TOWN OF ALPINE - PLAN REVIEW RECORD

PERMIT #: R1-12-24 DATE RECEIVED: 11-20-2024

Seversen Plan Review Code Sections

TOWN OF ALPINE - SITE PLAN REVIEW RECORD AND SITE INSPECTION

SITE PLAN

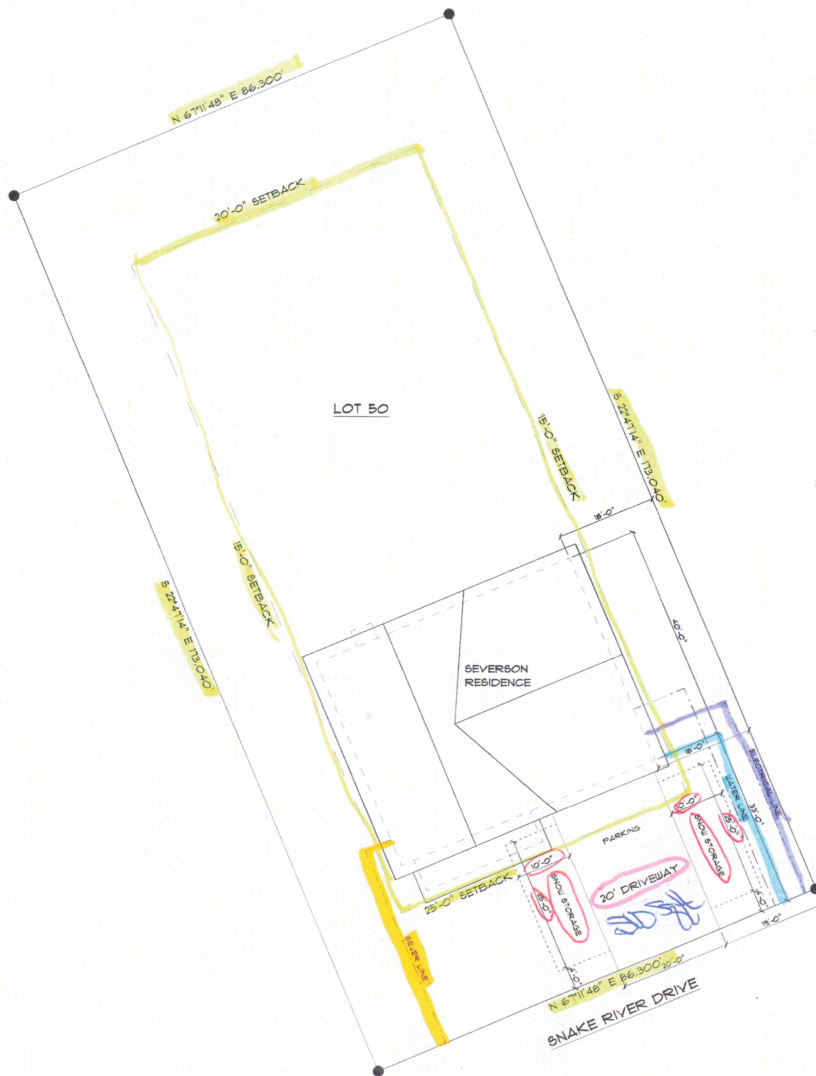
Dimension of parking & snow storage area
to be identified

Window + Entry = 7.5 sq ft

Project has: 100 sq ft;
w/o door window

Parking Area:

Driveway = 510 sq ft;

Garage -
 $22 \times 24 = 528$ sq ft

Combined: 1,028 sq ft

*DMU Storage
10x75 = 750 sq ft
@ 7
500 sq ft*
